APPLICATION FOR CERTIFICATION FOR  
THE HIDDEN HILLS SOLAR ELECTRIC GENERATING SYSTEM  
HHSEGS 11-AFC-02

# OPENING TESTIMONY

C.R. MACDONALD  
INTERVERNOR

TESTIMONY OF C.R. MACDONALD, INTERVENOR

**Photo 2**

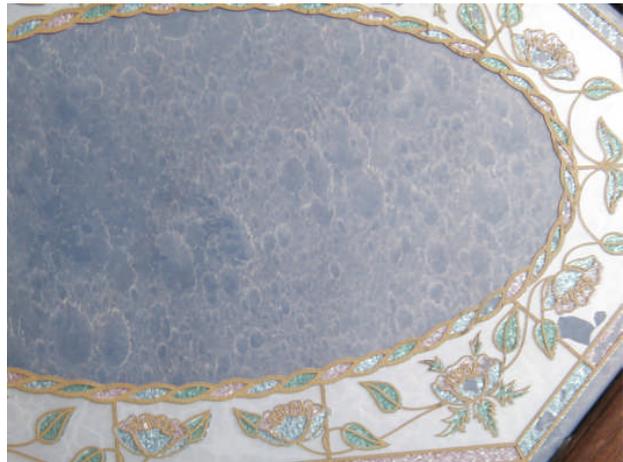
Same mirror after 35 days. 10/3/12

Note the water spotting on the mirror? This was caused from a light sprinkling of rain, which often occurs in the late summer months. I believe this will have a significant effect on the HHSEGS’s output and performance if maintenance activities are incapable of addressing these mirror distortions.

**Figure 3**  
 Peak ground accelerations for the proposed HHSEGS site  
 modeled by USGS using a 10% 50-year parameter.

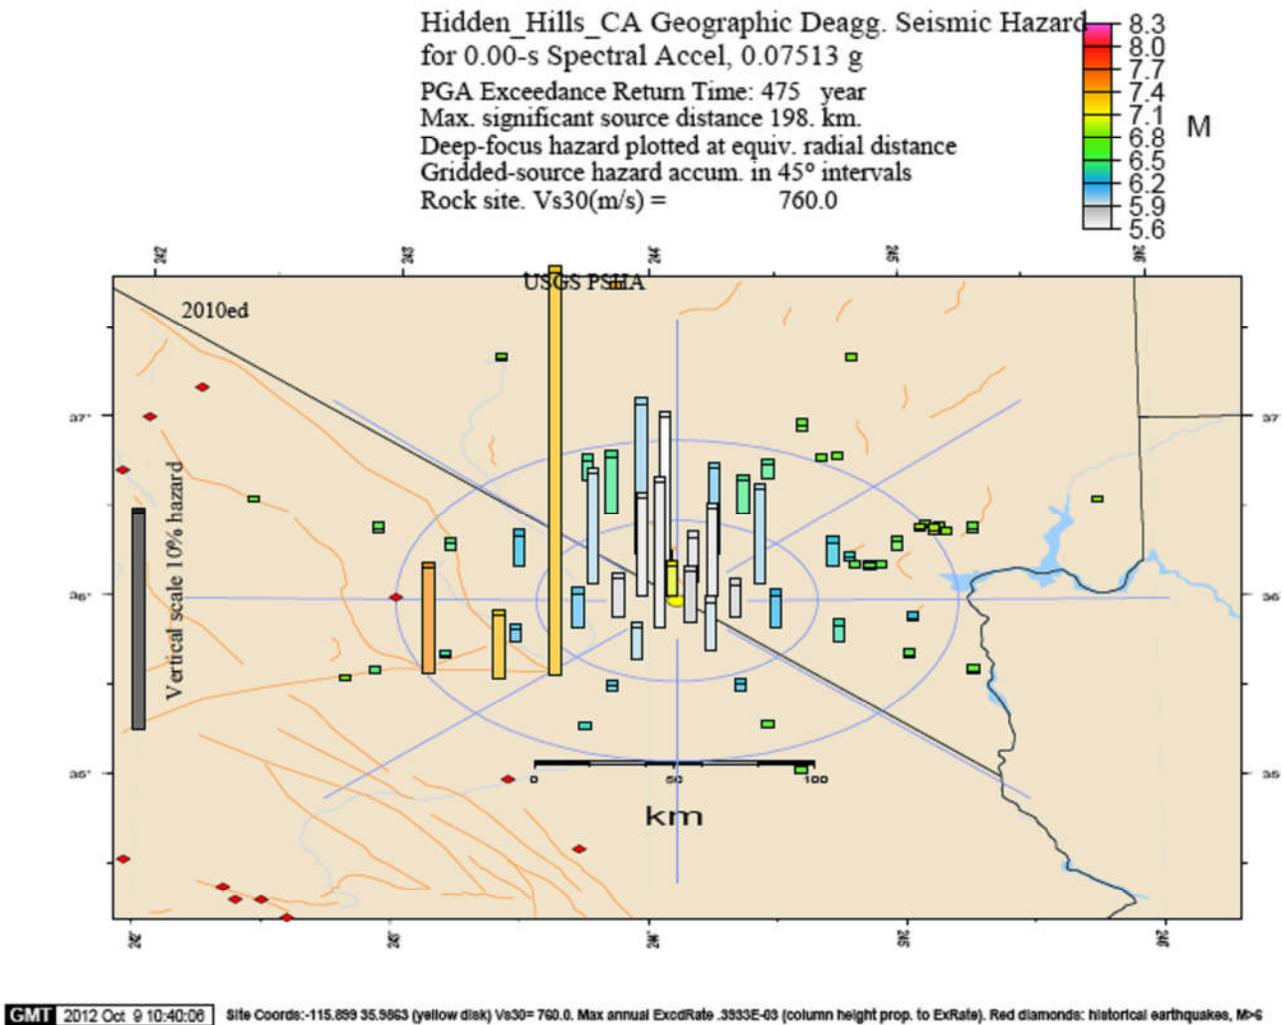
Figure 3, below, was a computer generated model of earthquake potentials at the proposed project site using latitude and longitude degrees provided in the AFC at 10% for 50 years.(28) The model was run using the USGS Earthquake Hazards Program, Interpolated Probabilistic Ground Motion for the Conterminous 48 states.(29) This helps visually illustrate potential earthquake impacts throughout the heliostat fields and area as well as why I have been attempting to pursue heliostat earthquake tolerances via the CEC Public Record Acts requests.

**Figure 1.**

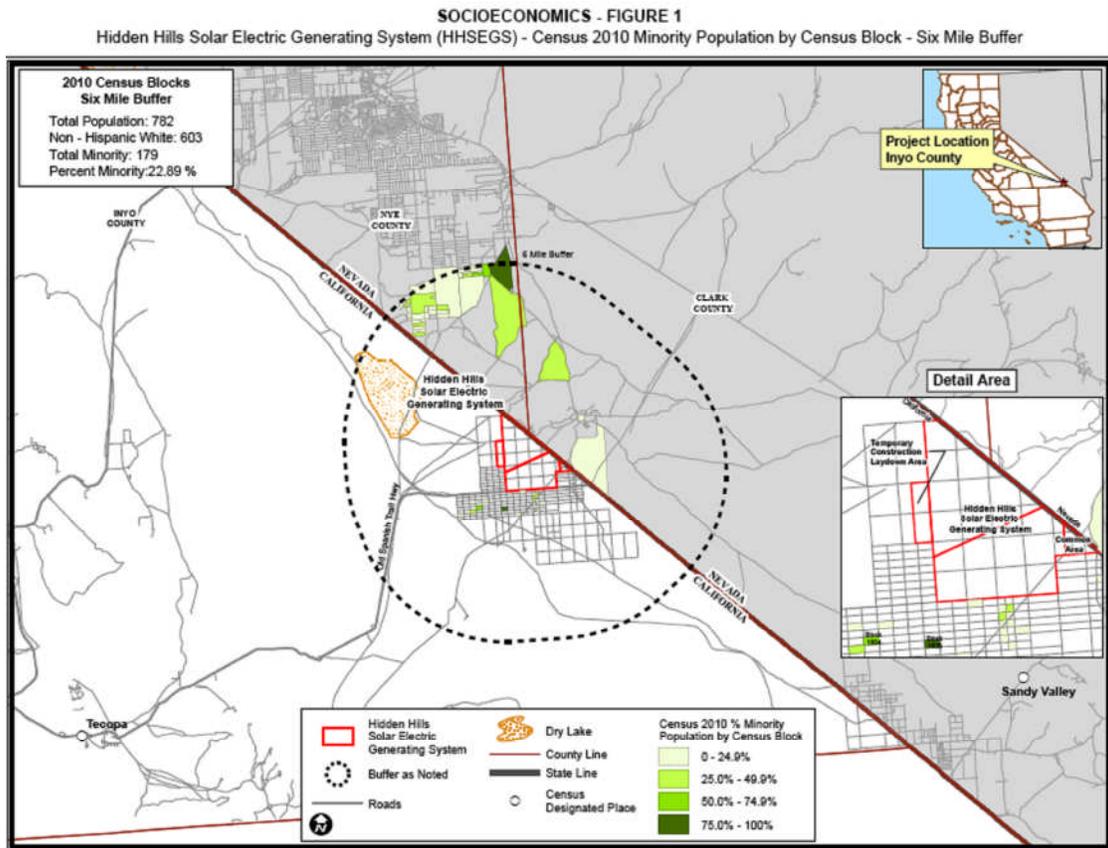
Third, Applicant’s suggestion that air quality data for PM10 windblown dust is exclusively a result of Pahrump while ignoring a significant contributor to PM10 emissions in the Pahrump Valley that is *also* “strongly affected” by windstorms, which is the Pahrump Dry Lake located slightly northwest of the proposed HHSEGS site and slightly southwest of the southern end of Pahrump.

Fourth, Applicant substitutes local air quality PM10 data from Pahrump in their air quality modeling for an area less representative of the Pahrump Valley, which Staff and the GBUAPCD agree with, despite the fact that Pahrump is represented in the FSA as being within a six-mile buffer zone of the proposed HHSEGS as illustrated in Figure 1.

**Figure 3. HHSEGS AFC Noise Monitoring Locations**

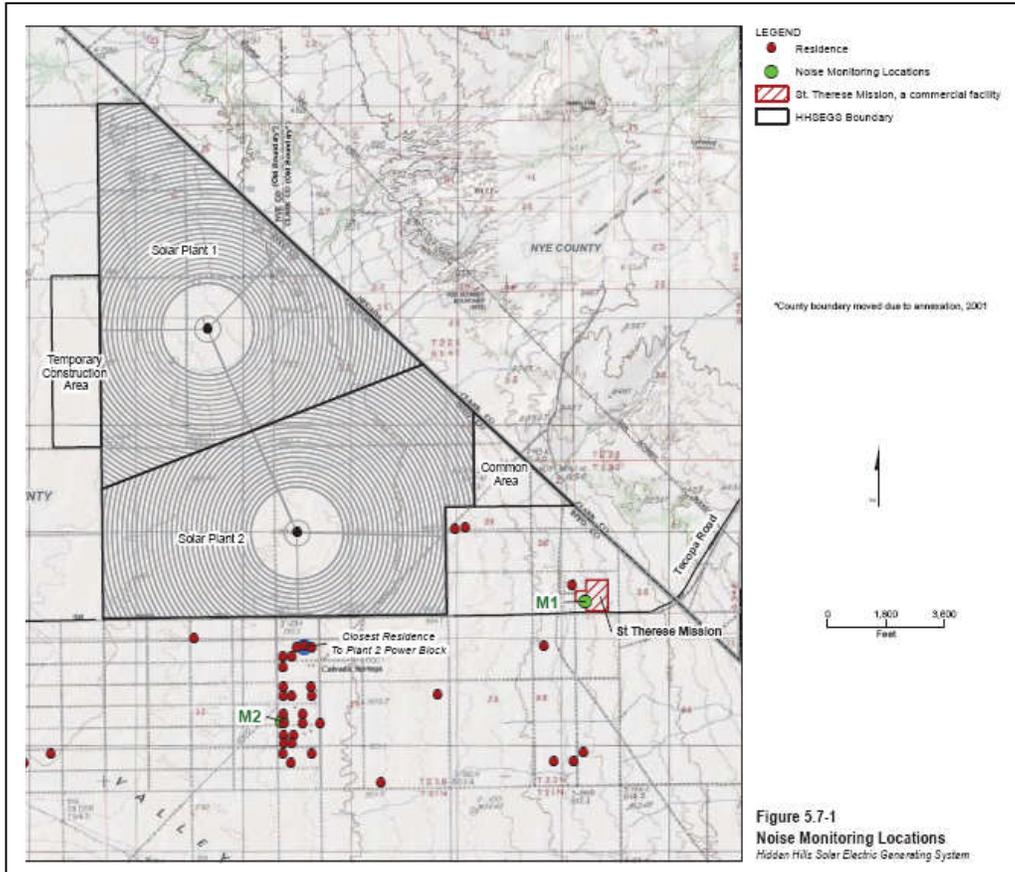
The use of the sound survey results at M2 were used by Applicant to calculate noise level impacts to the residence closest to the power block at Solar Plant 2, known as CR1, which is reported at 3500 ft. (0.66 miles) from the power block and 950 ft. south from the proposed project's boundary.

However, based on my experience in the area, a more accurate representation for CR1 would have used the St. Therese’s sound survey results because it would account for passing vehicle traffic on the Old Spanish Trail Highway/Tecopa Road since CR1 is much closer to the road than M2.

With respect to the higher level of recorded sound data at M2, the only thing that I can think of that might have driven up the recorded sound levels at this location is its proximity to a residence that is known for the occasional use of heavy equipment and temporary “projects”. Perhaps the sound test was performed during a time when this nearby residence was engaged in one such project or the sound monitoring equipment was placed next to a chicken coop with early morning crowing roosters. However, this would not be indicative of the overall ambient sound environment for Charleston View nor does it reasonably explain the large gap in survey results between the Charleston View residence and St. Therese Mission reported for 5:00 a.m. during the test period.
